ATTACHMENT 1 – Council Submission

SSDA 44-52 Anderson Street Chatswood

Map 5: Ground level setbacks proposed in SSDA

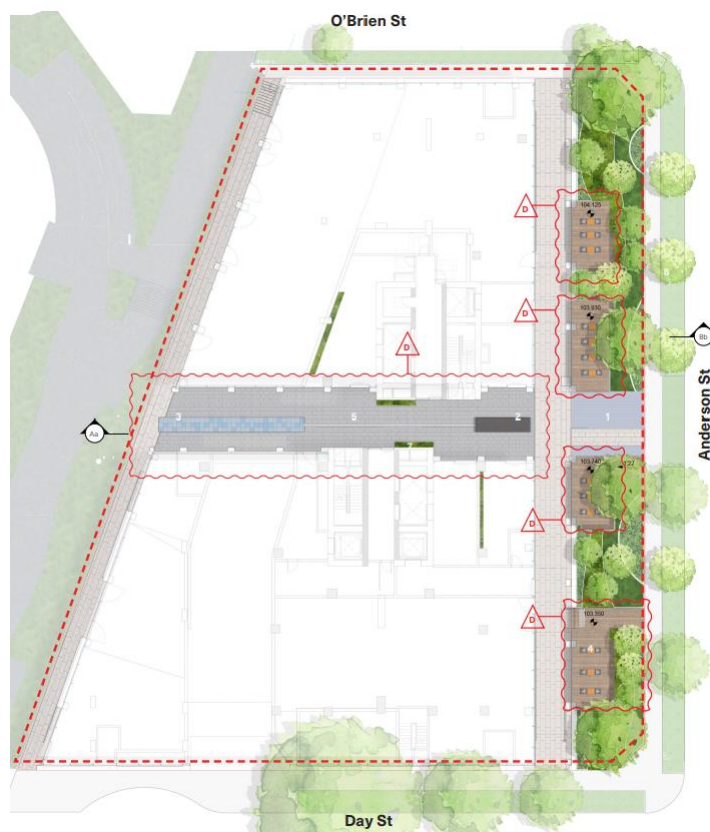
- The 6m Anderson Street front setback plays a critical role in providing significant planting opportunities to mitigate the 90m height permitted under WLEP 2012, having particular regard to the site being opposite the low density residential North Chatswood Conservation Area. Refer to WDCP, Part L, Section 13.1.10, Open Space and Landscaping, Control 6 above. Under the SSDA, height is proposed to be increased, and planting opportunities are reduced by the reduction in deep soil planting and the unanticipated provision of four large decked seating areas.

While it is reasonable for some hard paving within the Anderson Street setback for the purposes of access, this should be minimal as the intent for this area is for planting and soft landscaping. While minimal formal public seating is also supported, seating on the scale proposed is not considered appropriate for this setback location. If the proposed development seeks outdoor seating to serve restaurants, this should be designed outside the planned setback.

The reduction of deep soil planting opportunities within the 6m front setback to Anderson Street due to the encroachment of basements is not supported.

Map 6: SSDA Basement level 1

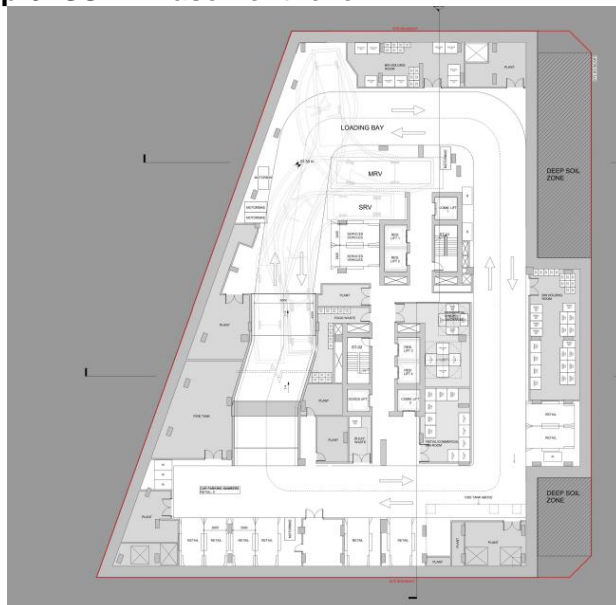
The encroachment of Basement level 1 provides for the bin holding room and car parking.

As discussed in this submission, excess car parking is provided in this SSDA. The removal of car parking within the front setback, being 66 car spaces over eight basement levels, is supported by Council as it is above the WDCP and WDCP / Housing SEPP car parking required – refer to car parking section. The further reduction of car parking would provide space for relocating the bin storage area, being 6 car spaces.

Map 7: SSDA Indicative other Basement levels

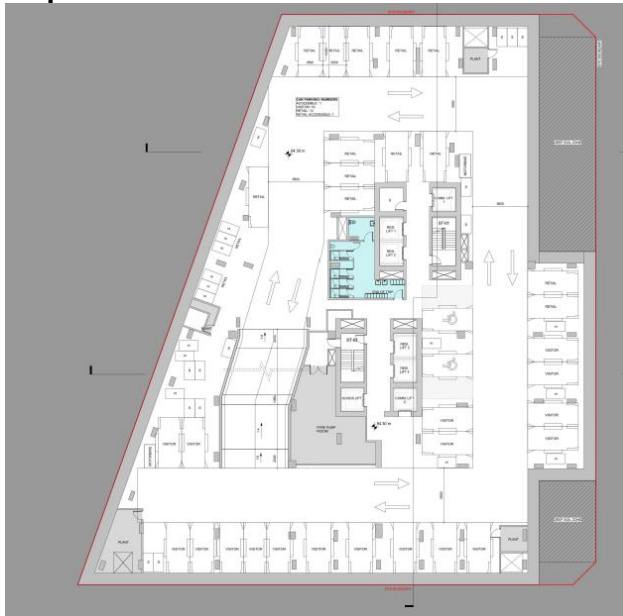
The encroachment on lower basement levels provides for car parking.

Map 11: Section extracts from Landscape Plans (left) Architectural plans (right) showing soil depth from 0mm to <350mm.

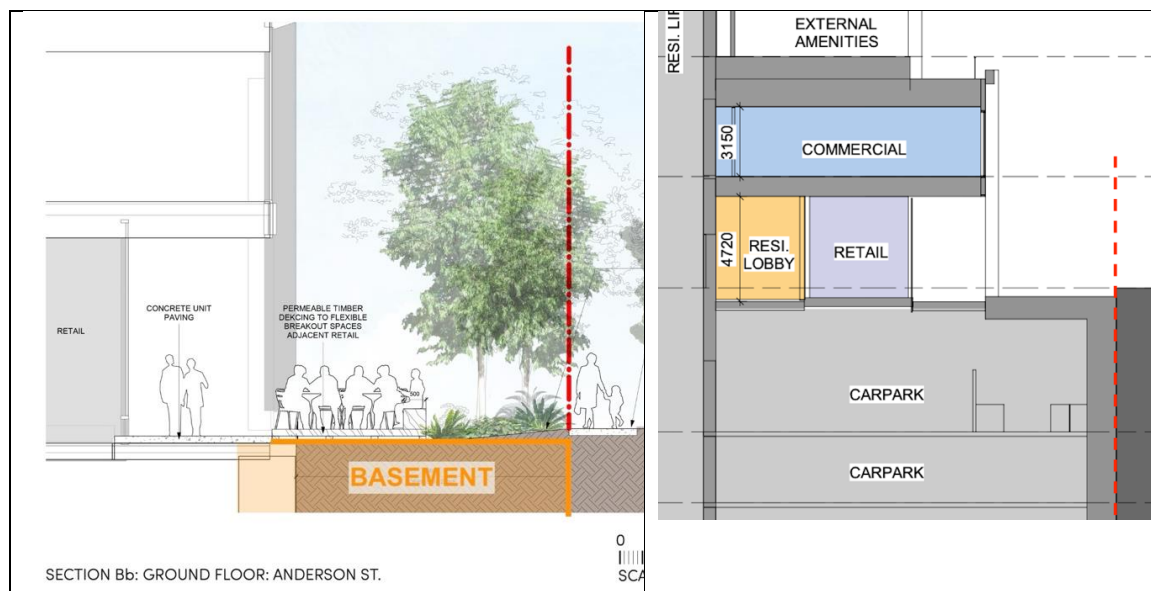
- Deep soil is provided to only 58% of the 6m setback frontage to Anderson Street, with the remainder being impeded by basement parking levels below.
- In addition to the deep soil zone being impeded, the landscape plan indicates the area within 6m setback containing basement parking levels below will have a soil depth of 1.2m – 1.5m. This is contradictory to the sections in the architectural plans, which show less than 350mm soil depth (noting a minimum of 600mm of soil depth is required for inclusion in landscape area calculations). The soil depth over the basement parking area is insufficient to support planting.

Map 12: Setback to western boundary as proposed

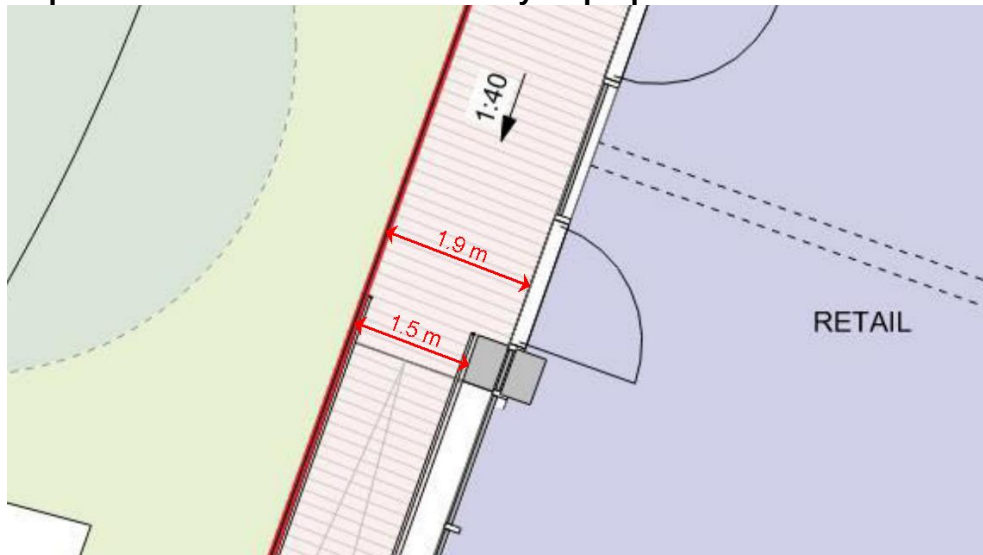
- There is an existing lapped and capped timber boundary fence that creates a solid screen. Removal of the fence will be required to allow at least a visual connection with the adjoining landscaping and pathway. The plans do not note removal of the boundary fence – this should be noted on plan and conditioned in any approval.

- A full 2m setback is required without encroachments on the western boundary. Measuring from the plans appear to show a 1.9m setback, with pillars and some elements encroaching on the setback reducing it some areas to 1.5m; (noting this is measured from the plans, and a dimension was not shown for the setback). Dimensions consistent with the site specific DCP are required on plan.

- The plans currently show no landscape embellishments within the 2m setback to the western boundary which are expected. Landscape embellishments may include planting and minimal bench seating (secondary to planting). The embellishments must consider the existing landscaping on the neighbouring to integrate the spaces to the public benefit.
